### **IN THE DRAWINGS**

## REMARKS

FIG. 13

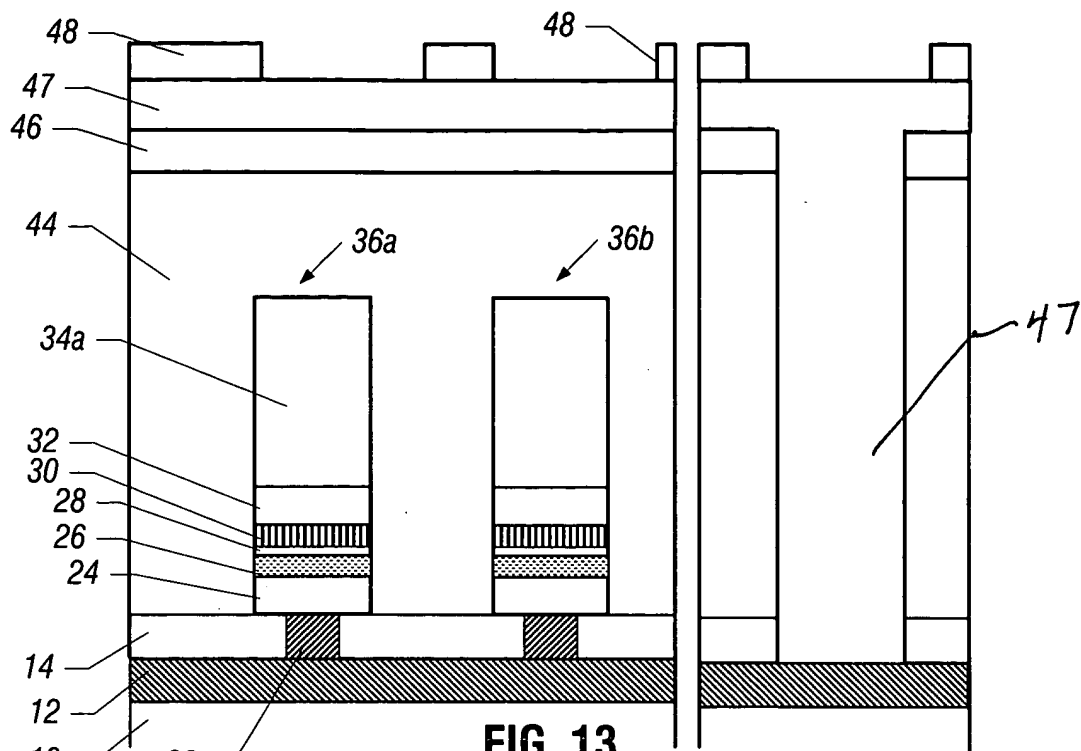
Figure 13 has been amended as indicated in red in the attached annotated marked-up drawing. A replacement sheet of Figure 13 is also attached.

With respect to the objection to Figure 14, it is believed that adding the reference numeral to Figure 13 will clarify the issue. In other words, in Figure 13, the groove in the periphery is filled with the sacrificial light absorbing material 47. See the specification at page 12, line 7.

FIG. 14

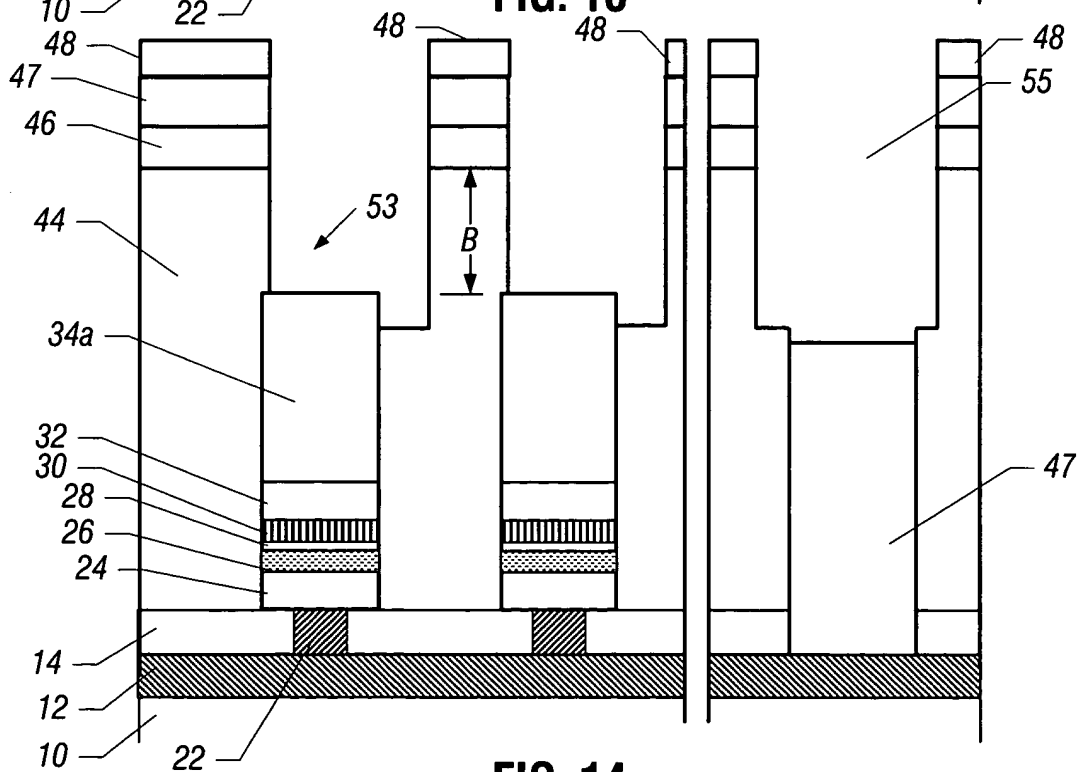
It is also indicated that it is unclear why claim 17 further discloses etching said groove in the periphery into the sacrificial light absorbing material. This is seen by comparing Figures 13 and 14 with the groove 55 resulting in Figure 14.

With respect to the question about why the groove in the periphery could be claimed to be deeper than the groove in the memory array, the groove 55 and 53 may be compared to see that the drawings do show this feature.
